# Service Bulletin No. 356

<b>MODEL</b> E / J Series Coaches	<b>TYPE</b> Field Change Program	<b>SECTION/GROUP</b> 7 – Electrical	<b>DATE</b>
<b>SUBJECT</b> DOGA WINDSHIELD WIPER MOTOR WIRES			
<b>CONDITIONS</b>

Figure 1.

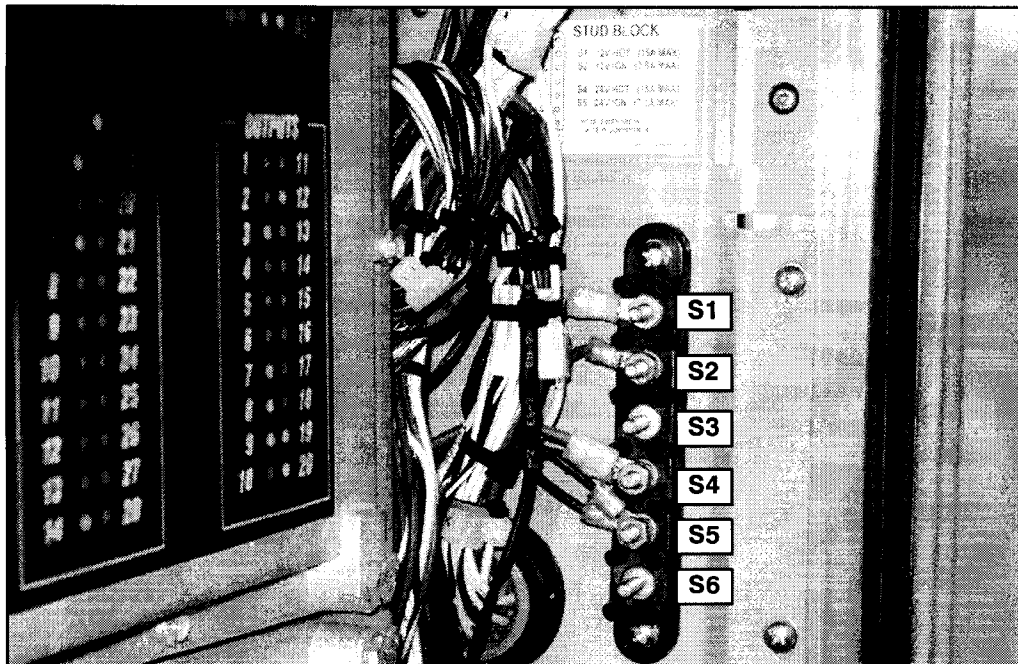
MCI has identified a potential incorrect installation of the wiring which occurred in the manufacturing facility. If the wiring is incorrectly installed, the wiper motor will be powered from a lower rated fuse, which may open under heavy load such as high winds, heavy rain or a dry windshield. If this occurs, the windshield wipers may completely stop operating. If the windshield wipers stop functioning, the driver’s clear field of view may be reduced.

The wiring connections in the front junction box for the circuit powering the wiper system may be incorrect.

4. Locate the stud block on the compartment wall ( refer to Figure 1 ).
5. Visually inspect to verify that the red wire, 1285A, is connected to stud block S4.
6. Visually inspect to verify that the black wire, 1244A, is connected to stud block S5.

*If the wires are installed properly, no further action is required. Close the front service compartment door. Procedure complete.*

*If the wires are not installed properly, using a nut driver remove the red and black wires and re-connect them per Steps 5. and 6. Close the front service compartment door. Procedure complete.*
